# PHILADELPHIA ELECTRIC COMPANY

April 4, 1983

Subject: Limerick Generating Station, Units 1 and 2  
Reference: Letter A. Schwencer to E. G. Bauer, Jr., dated  
February 7, 1983  
File: GOVT 1-1 (NRC)

The reference letter transmitted the Mechanical Engineering Branch (MEB) Draft SER which contained open items. As a result of meeting with MEB on March 22-24, 1983, most open items were resolved. Enclosed is a summary listing of the status of each open item. The final responses to MEB concerns and related FSAR page changes that were discussed at the March 22-24 meeting are enclosed also. The FSAR changes will be incorporated into FSAR Revision 19 in April. We will be scheduling meetings with MEB within two weeks to resolve the few outstanding open items.

JOB NO. 8031  
EMERGENCY SERVICE WATER SYSTEM  
P&ID 8031-M-11, SHEET 1, REVISION 18

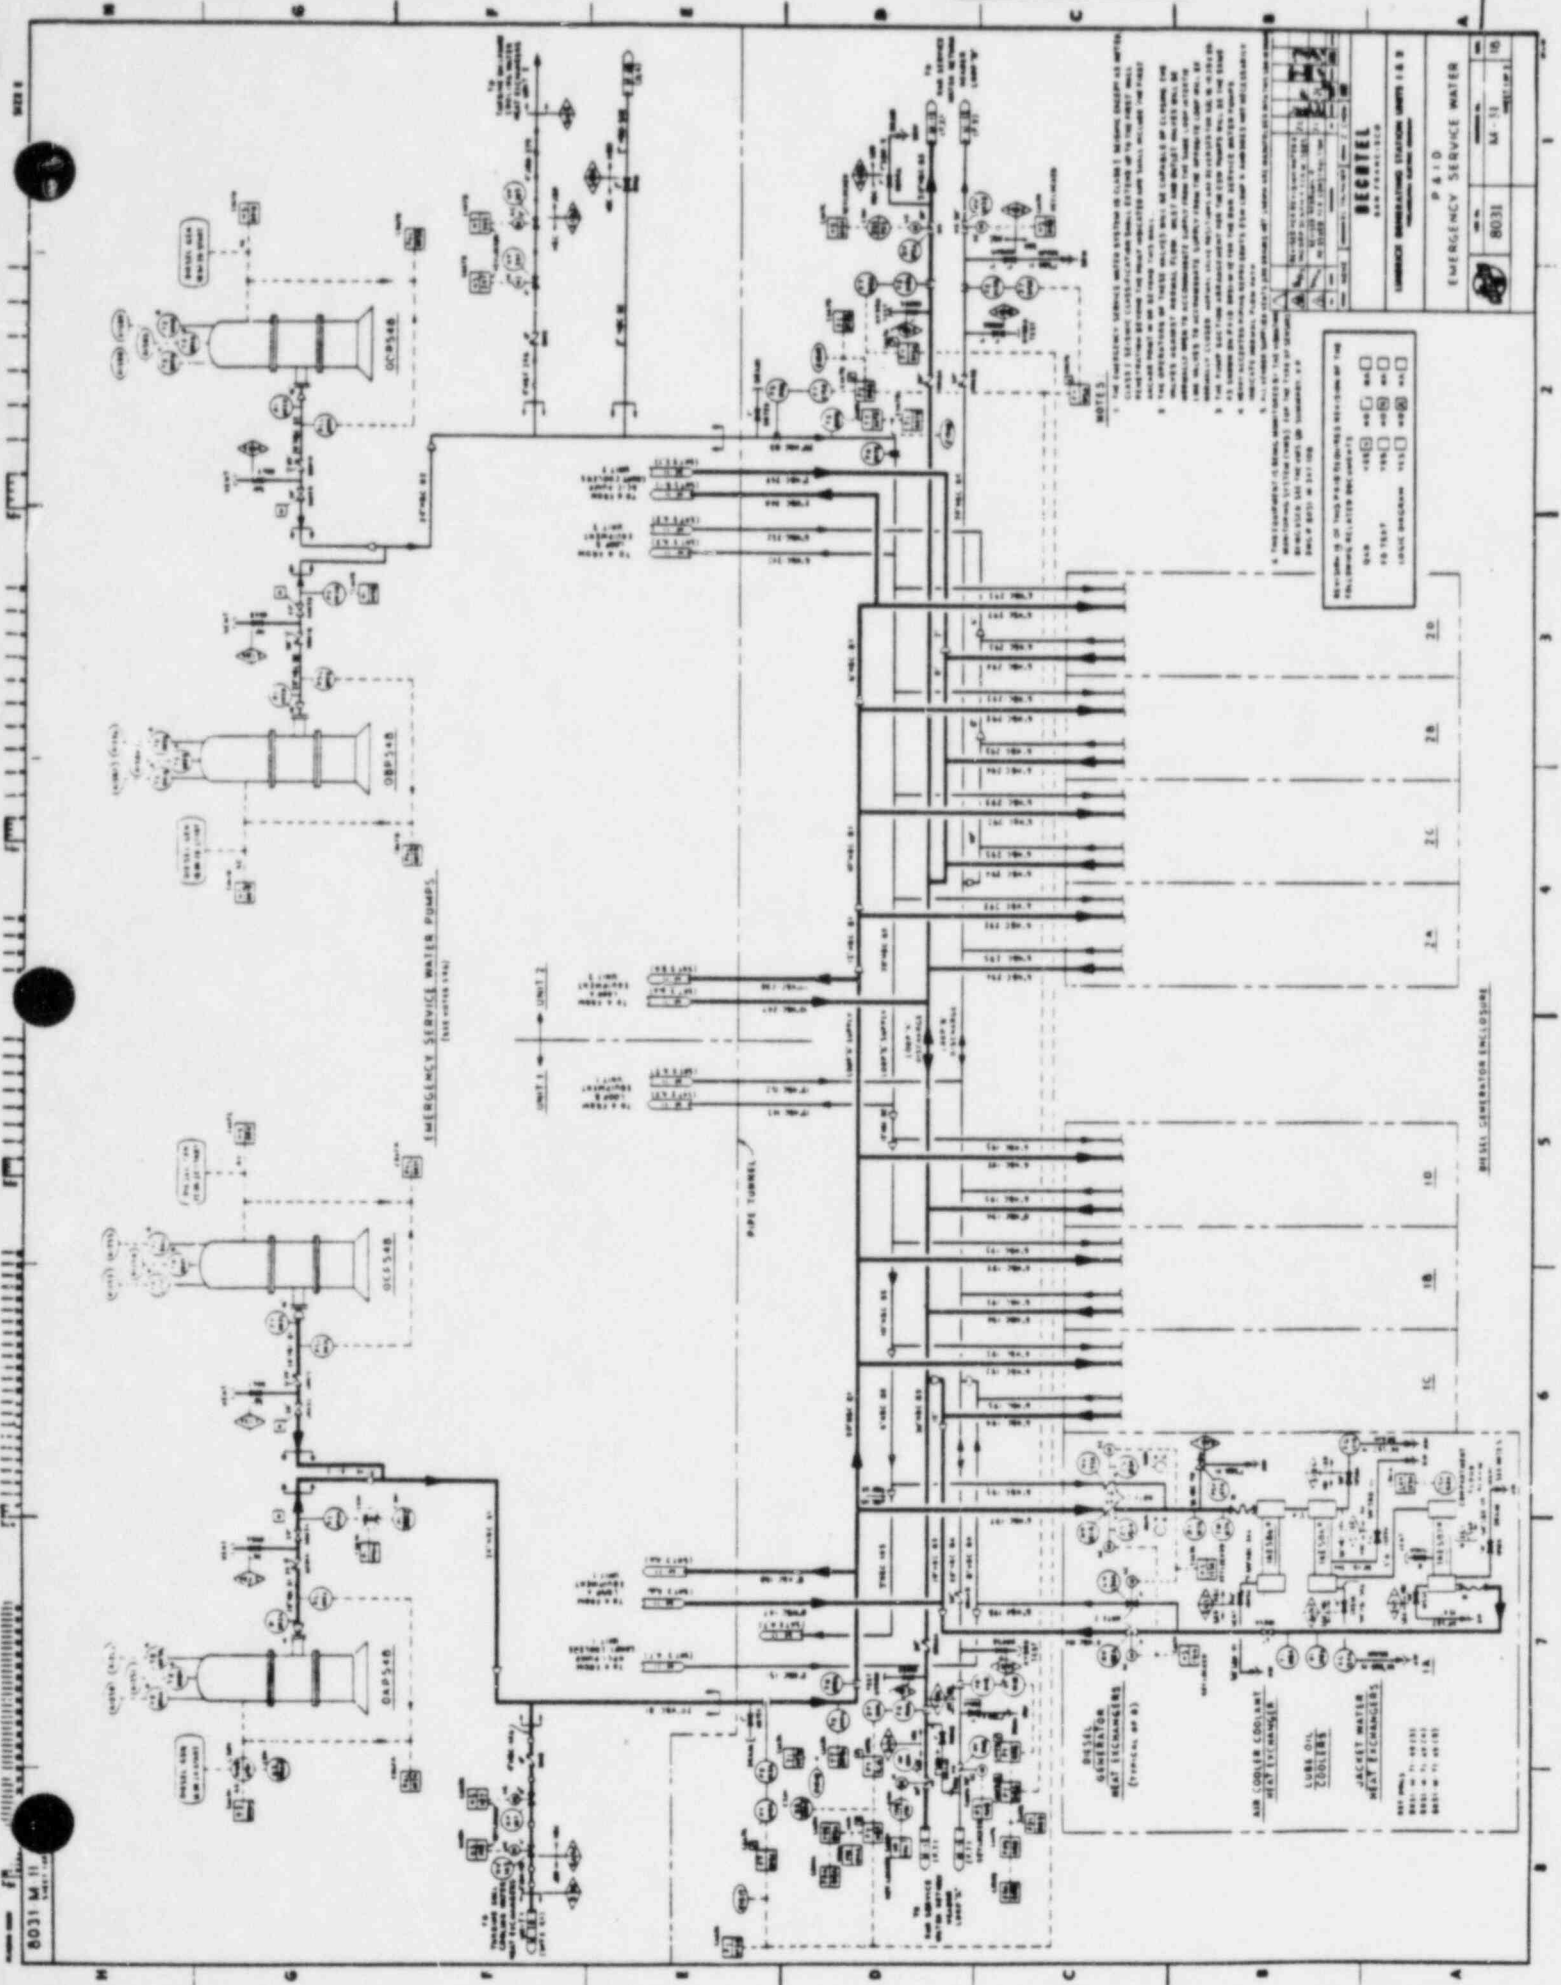
QUESTION NO. 11  
(Table 3.2-1)

Sheets 1, 2 and 3 of Figure 9.2.2 indicate the parts of the Emergency Service Water System that are Seismic Category IIA. Non-Seismic Category I drain and vent lines and capped ends extending from Seismic Category I piping are Seismic Category IIA downstream of the last isolation valve.

REVISED NOTE 2 FOR CLARIFICATION.

ADDED NOTE 6 PER DCN 14 AND PLB-12,415.

ADDED DRAIN VALVES 11-0072A&B PER  
FCR-M-13,885.

LIME RICK GENERATING STATION  
 UNITS 1 AND 2  
 FINAL SAFETY ANALYSIS REPORT  
 STANDBY DIESEL GENERATOR AND  
 PLANT FUEL OIL SYSTEM  
 FIGURE 8-2-4 sheet REV 12, NOV 80

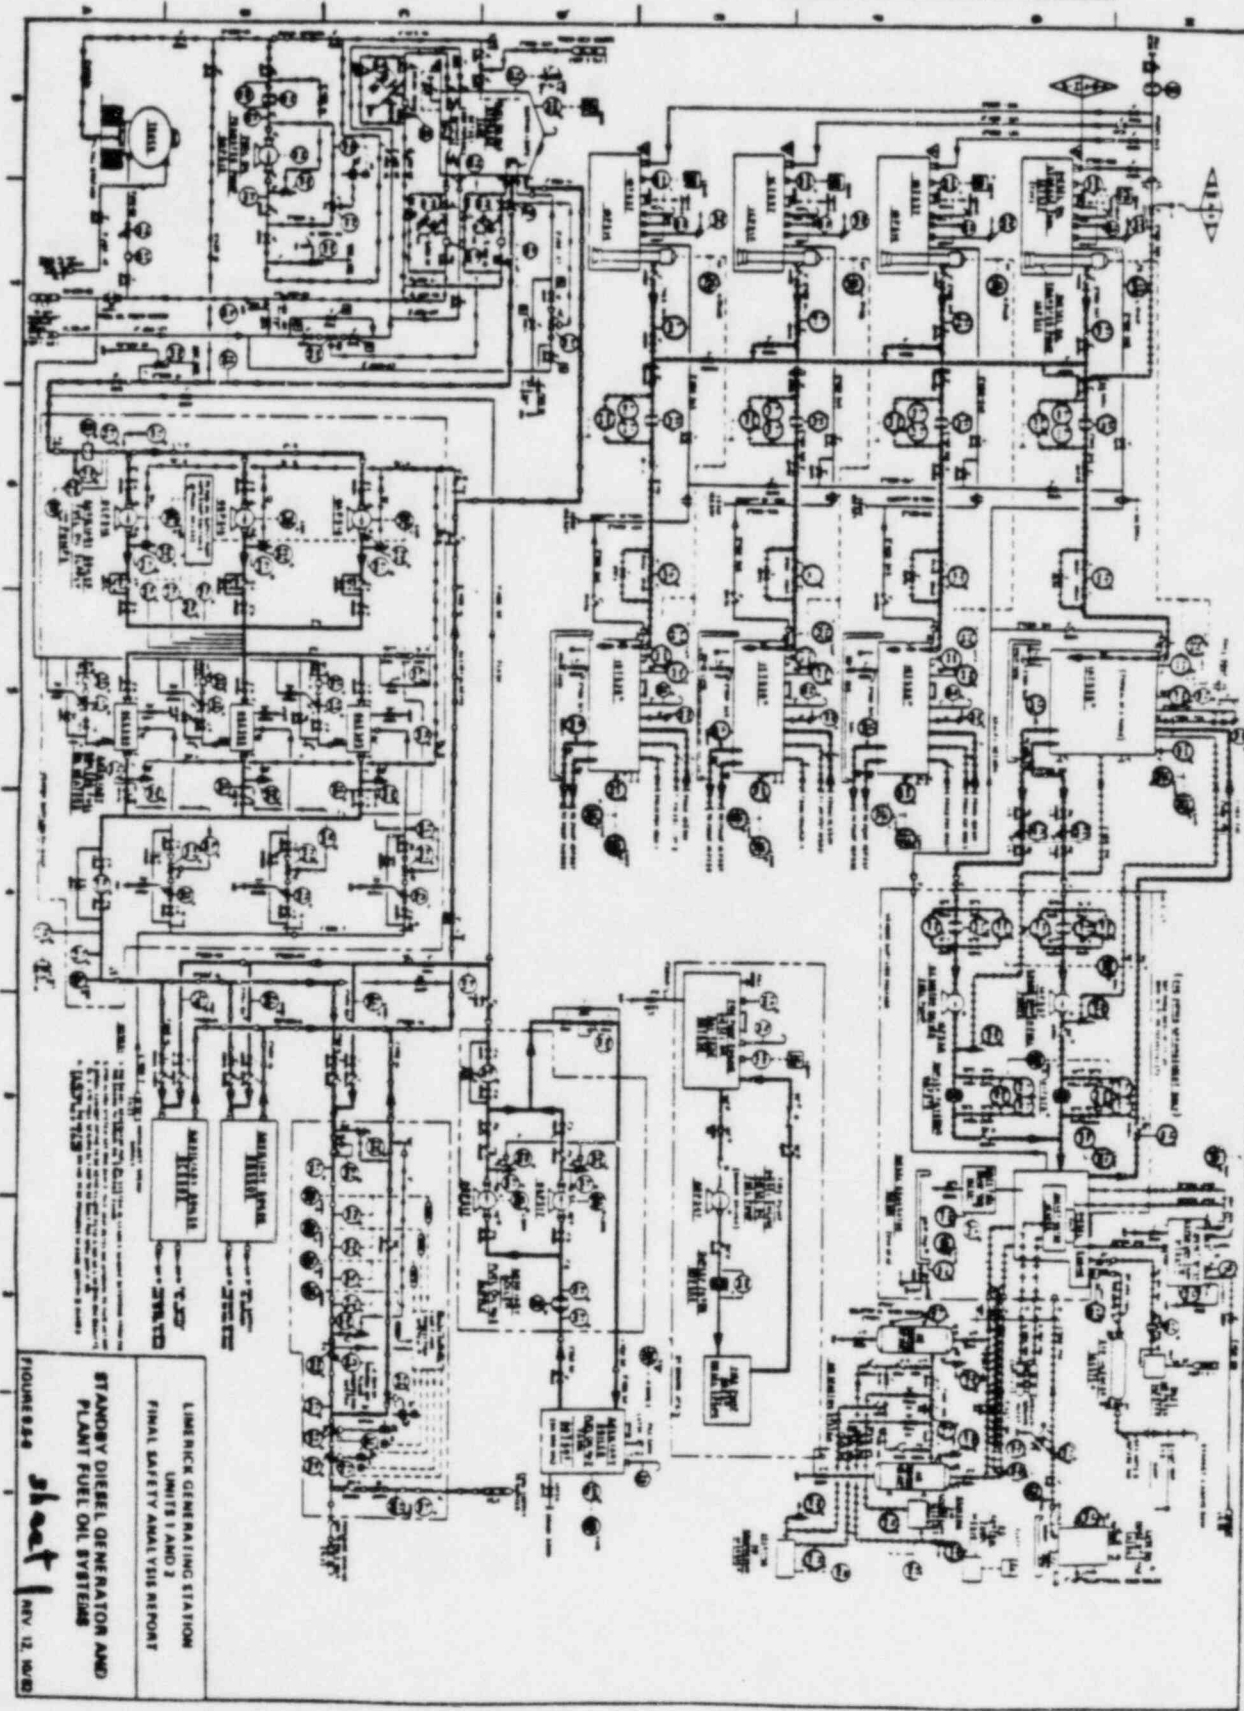
Diesel generator auxiliary systems piping and components are classified in the FSAR text and Table 3.2.1 as conforming to ASME Section III Class 3, ANSI B31.1, or manufacturer's standard. It is not entirely clear where the respective classifications begin or end. In any event, this is not acceptable. We require the entire diesel generator auxiliary systems to be designed to ASME Section III Class 3, or Quality Group C, in accordance with Regulatory Guide 1.26. Revise your FSAR accordingly. Also, provide the industry standards that were used in the design, manufacture, and inspection of the diesel engine mounted piping and components. Revise the appropriate P&IDs to show where quality group changes occur.

- a. Fuel oil system (Figure 9.5-8)
- b. Cooling water system which includes the jacket water cooling loop and the air cooler coolant loop (Figure 9.5-9)
- c. Starting system (Figure 9.5-10)
- d. Lubrication system (Figure 9.5-11)
- e. Combustion air intake and exhaust system (Figure 9.5-12)

FIGURE 3.9-9

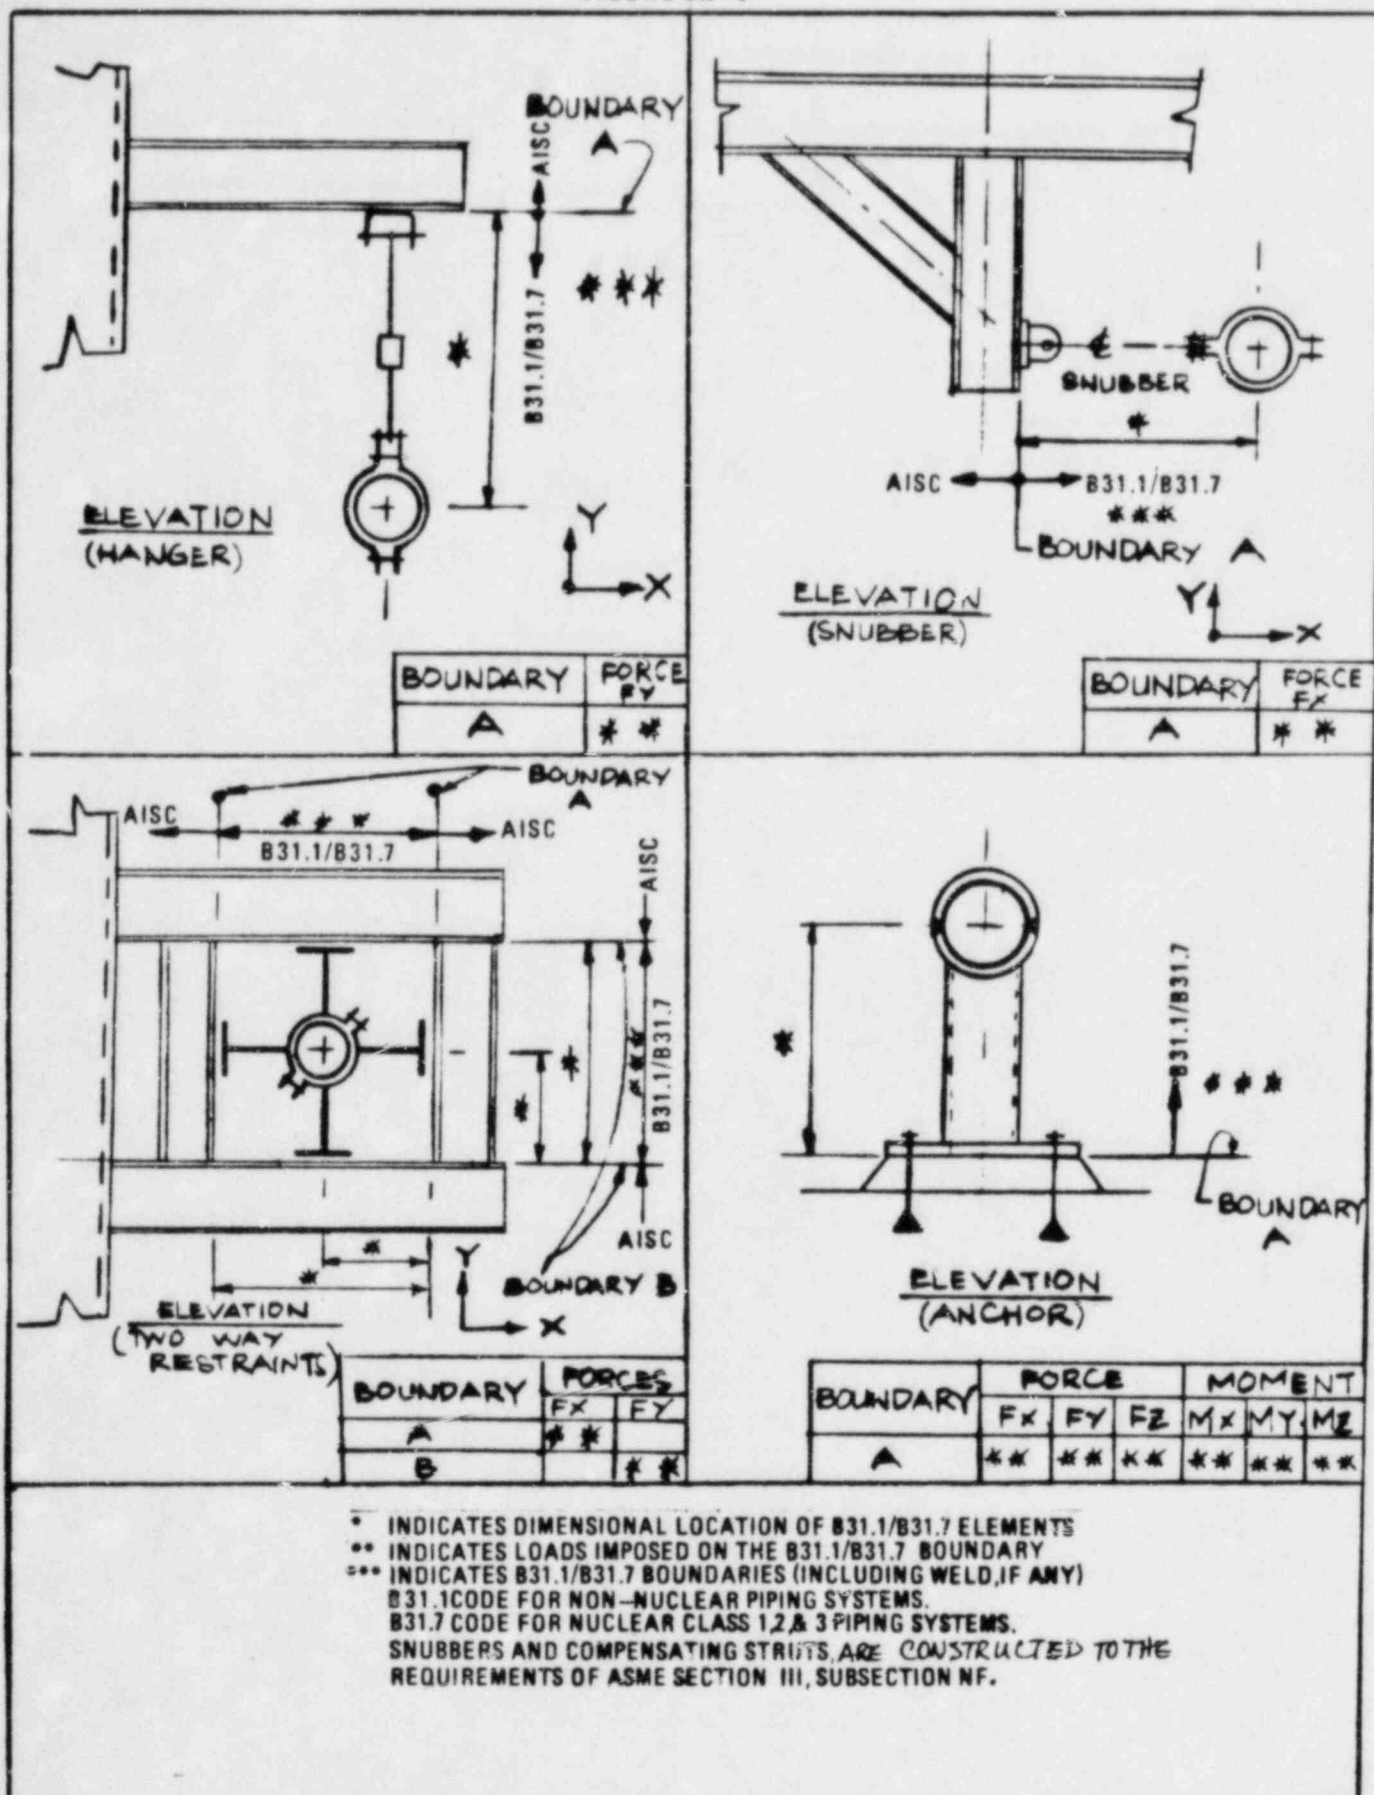
Provide a graphic summary of your interpretation of Subsection NF boundaries.

Section 3.9.3.4.2 is revised and Figures 3.9-9 and 3.9-10 are added to show the jurisdictional boundaries for the pipe supports.
